# UNITED STATES PATENT AND TRADEMARK OFFICE

APPLICATION NO.	FILING DATE	FIRST NAMED INVENTOR	ATTORNEY DOCKET NO.	CONFIRMATION NO.
10/597,923	12/27/2006	Claudiu Vasilescu	VAL 223 P2 / MFR 0204 PCT	7907
34232	7590	11/26/2008	EXAMINER	
MATTHEW R. JENKINS, ESQ. 2310 FAR HILLS BUILDING DAYTON, OH 45419			DESAI, NAISHADH N	
		ART UNIT	PAPER NUMBER	
		2834		
		MAIL DATE		DELIVERY MODE
		11/26/2008		PAPER

<b>Office Action Summary</b>	<b>Application No.</b>	<b>Applicant(s)</b>	
	10/597,923	VASILESCU, CLAUDIU	
	<b>Examiner</b>	<b>Art Unit</b>	
	NAISHADH N. DESAI	2834

## DETAILED ACTION

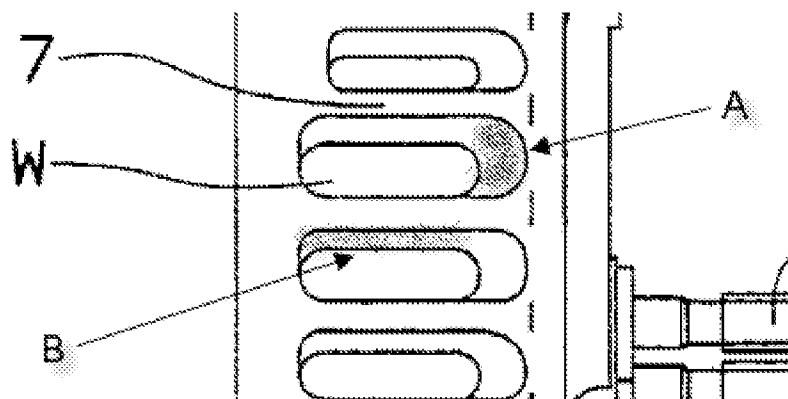
said air inlet and outlet ports each comprising an opening cut in the outer shell and subdivided by mechanical supporting fins each elongated according to a profile specific thereto (Figs 1 and 2), in which a radial port is made on a radial face overall of longitudinal orientation of the outer shell and has a substantially cylindrical overall shape coaxial with the longitudinal axis (see re-illustration of Fig 7, labels A and B below),

wherein at least one fin referred to as a radial fin of said radial port, considered in a plane tangential to said radial port at the level of said radial fin, extends in a general direction forming an angle greater than  $0^\circ$  with respect to a longitudinal direction (Figs 2-5 and re-illustration of Fig 7, labels A and B) so that edges of the fan with blades turned towards said radial port progressively sweep across the radial fin according to its profile while turning about the rotary shaft (Figs 2-5 and re-illustration of Fig 7, labels A and B), in a shearing movement whereby at each instant only one substantially point-shaped portion of an edge of the blade is opposite the radial fin (it is inherent that only one edge of the blade would be opposite the fin at each instance, unless there is more than one blade located above or below each other in the radial direction).

Kanaya et al teaches a rotary machine having variably-dimensioned housing ventilation holes. Kanaya et al does not appear to literally mention that the fins and or holes are inclined in the longitudinal direction. However, Fig 7 shows that the walls have both radial and longitudinal inclined angles greater than zero degrees and read on applicant's claim language (see re-illustration of Fig 7, labels A and B above). It would have been obvious to one having ordinary skills in the art at the time the invention was made to change the shape of the inclined walls to also be longitudinally inclined. The motivation to do so would be that Kanaya et al teaches the fins to have a curved profile and a section with variable size (Figs 2,4,5,7 and 8) and that it would increase the flow of cooling air and reduce whizzing sounds and noise (abstract).
